## HISTORIC AND DESIGN REVIEW COMMISSION

**HDRC CASE NO:** 2017-321  
**ADDRESS:** 415 CEDAR ST  
**LEGAL DESCRIPTION:** NCB 2968 BLK 3 LOT 4  
**ZONING:** RM-4, HS  
**CITY COUNCIL DIST.:** 1  
**DISTRICT:** King William Historic District  
**LANDMARK:** Pfeiffer, A - House  
**APPLICANT:** Jim Poteet/Poteet Architects  
**OWNER:** Kate and James Ball  
**TYPE OF WORK:** New Ribbon Driveway; rear concrete pad  
**REQUEST:**

The applicant is requesting a Certificate of Appropriateness for approval to:

# SITE PLAN

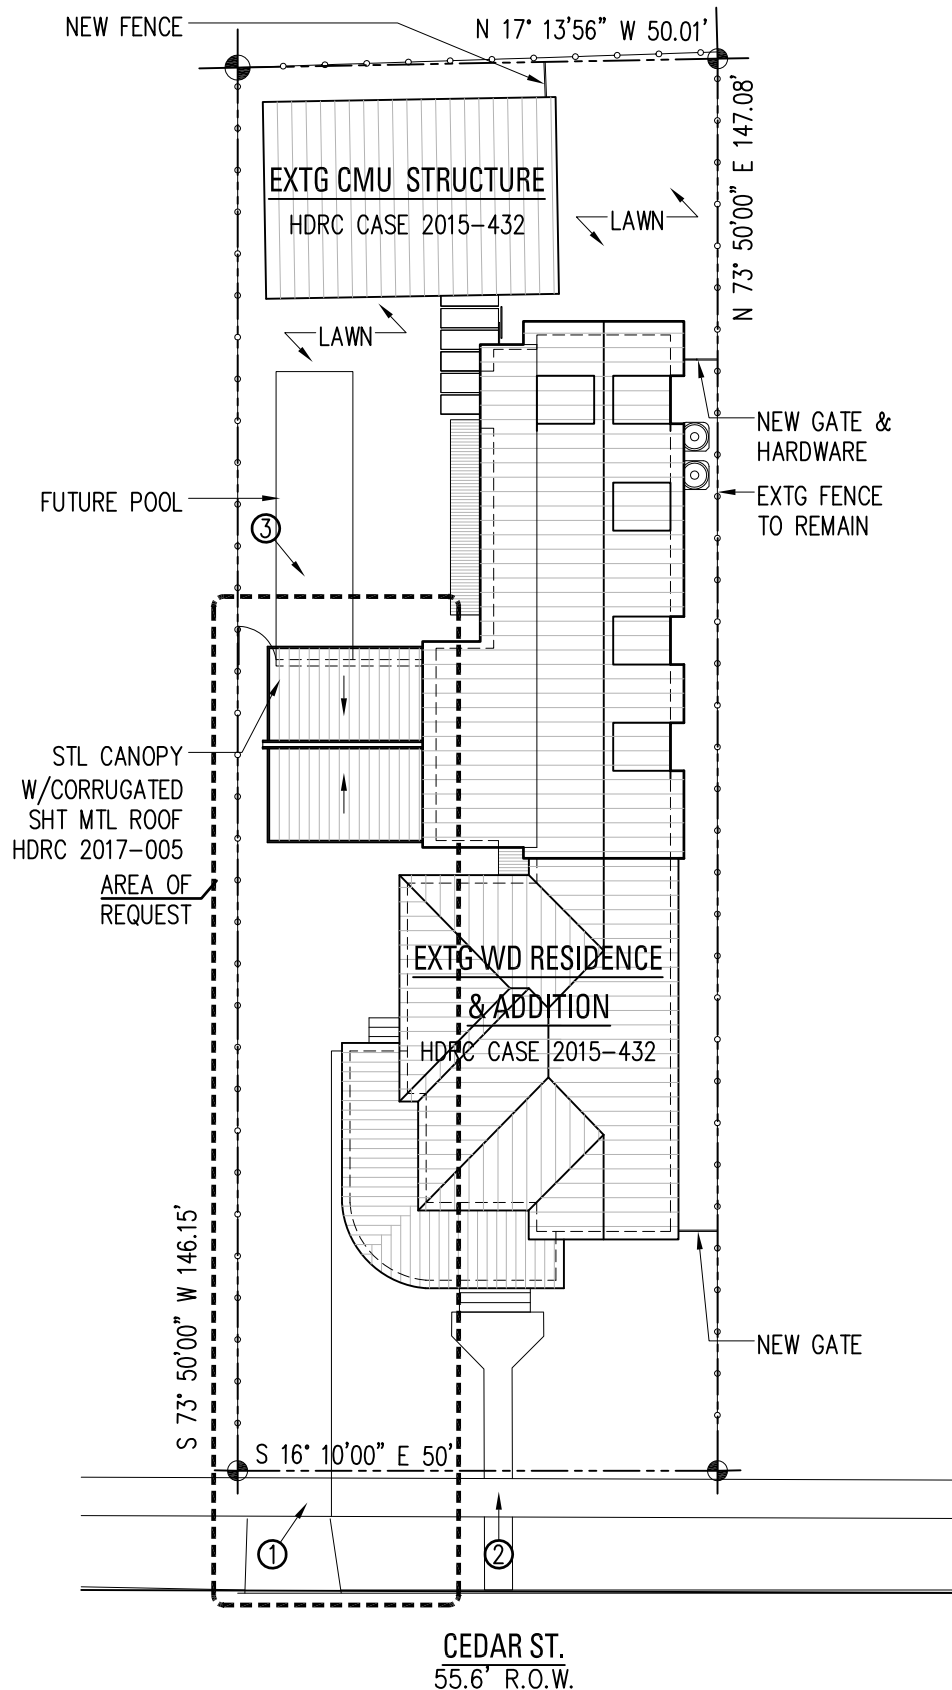
- c. **REAR CONCRETE PAVING** – Toward the rear of the property, the applicant has proposed to install a concrete parking pad to facilitate vehicular traffic to the rear steel carport, approved by the HDRC on January 18, 2017. The applicant has proposed two separate paved areas, the front consisting of 24” x 16” grasscrete pavers and the second, at the rear of the property, concrete. Staff finds the proposed installation appropriate given its location and

incorporation of a pervious materials that incorporates landscaping.

Staff recommends approval of items #1 and #2 as submitted based on findings b and c.

# PARTIAL SITE PLAN: DRIVEWAY

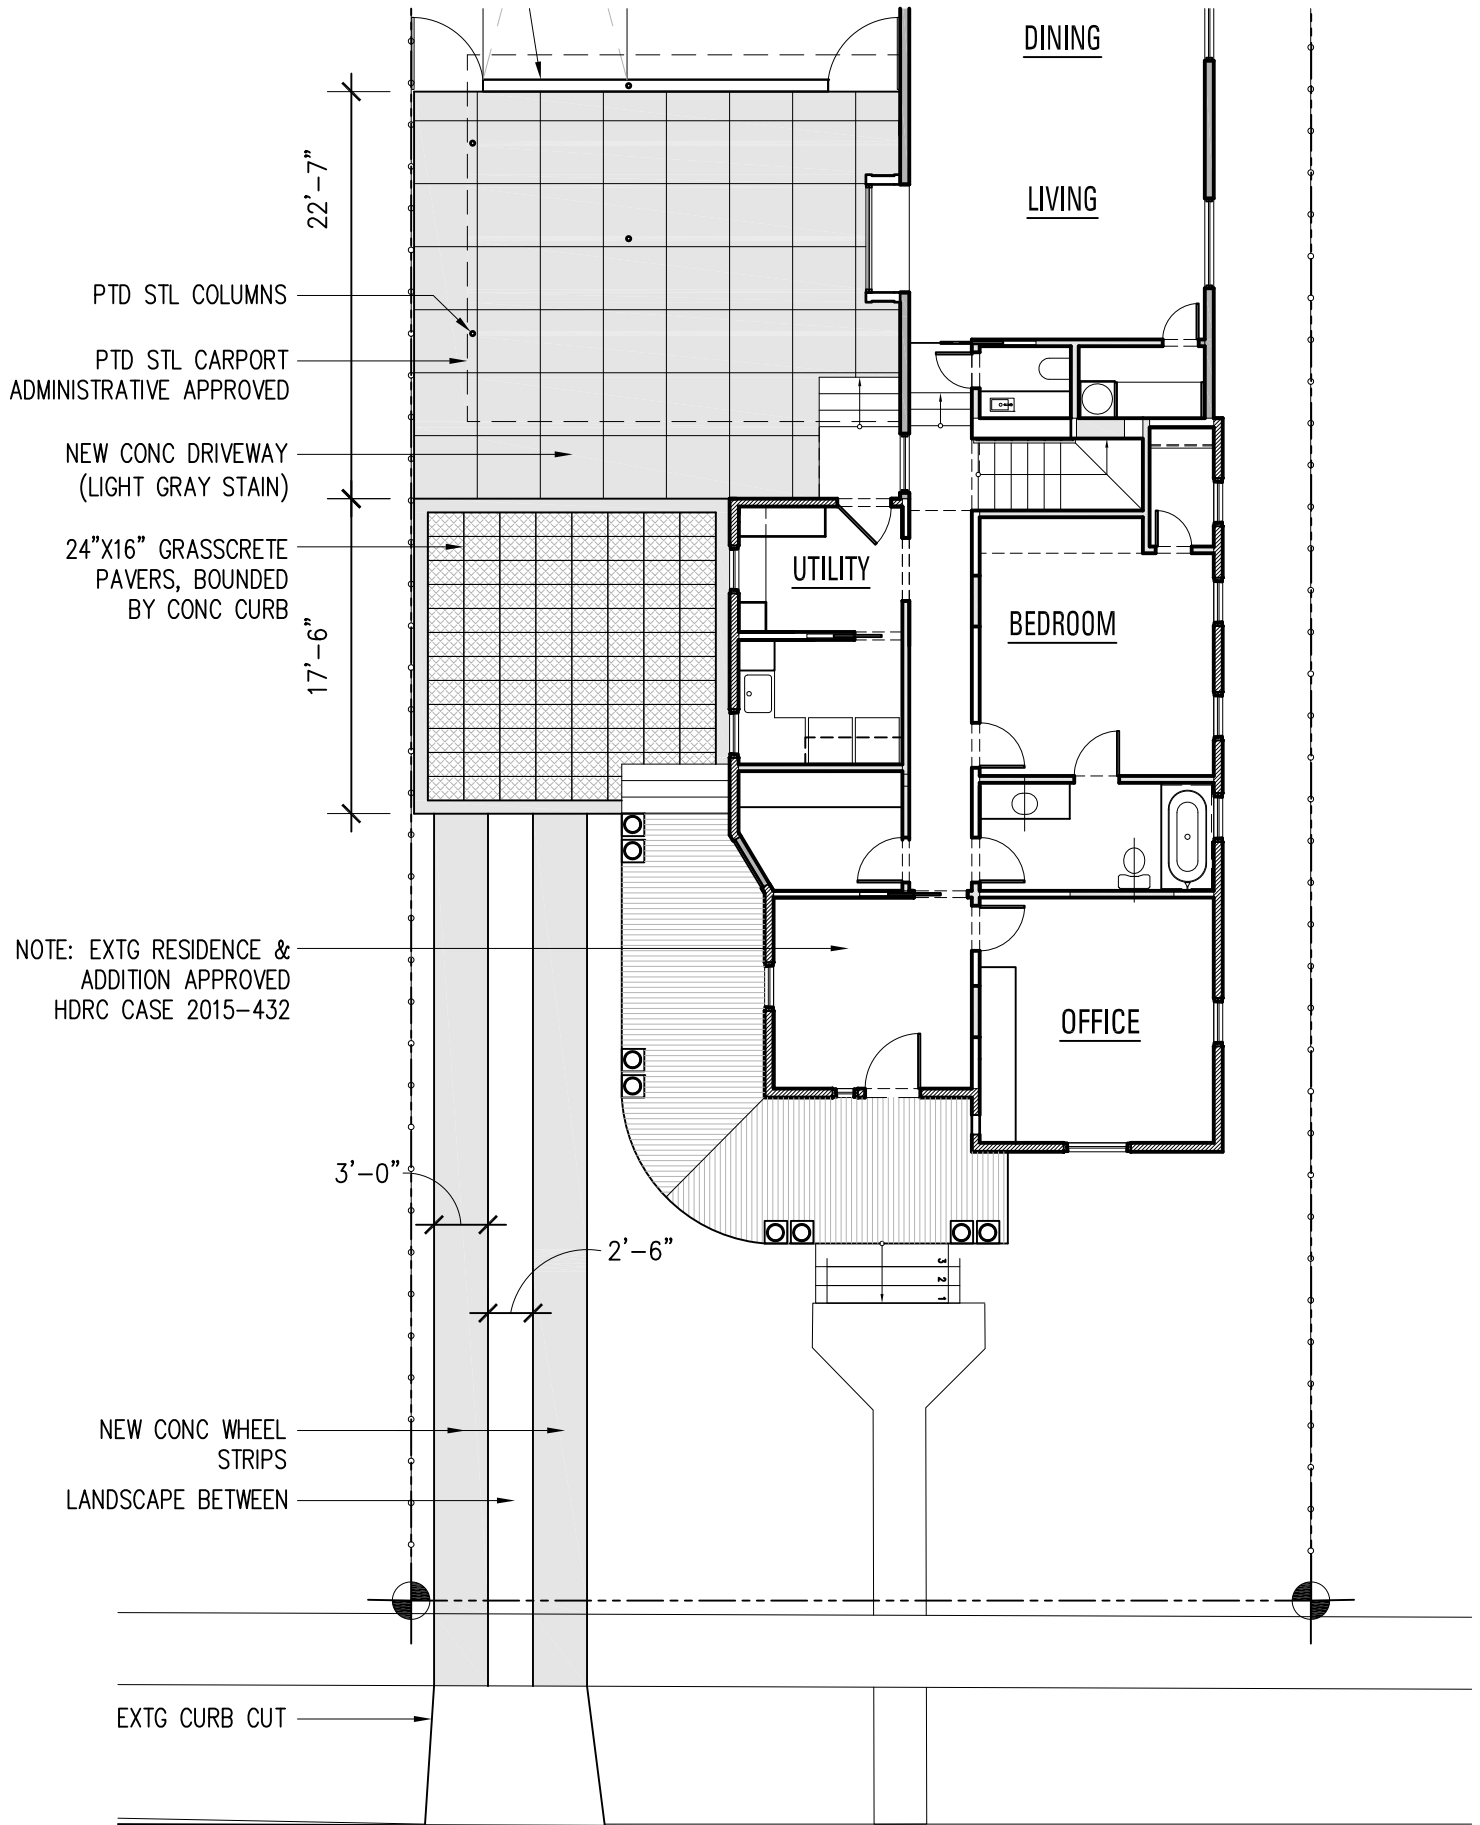
- b. **DRIVEWAY** – At this time, the applicant has proposed to amend the previously approved driveway design to include a concrete, ribbon strip driveway. Per the Guidelines for Site Elements 5.B.i. a similar driveway configuration should be used to those found historically throughout the district in regards to materials, width and design. The proposed concrete, ribbon strip driveway is appropriate for the King William Historic District and is consistent with the Guidelines.
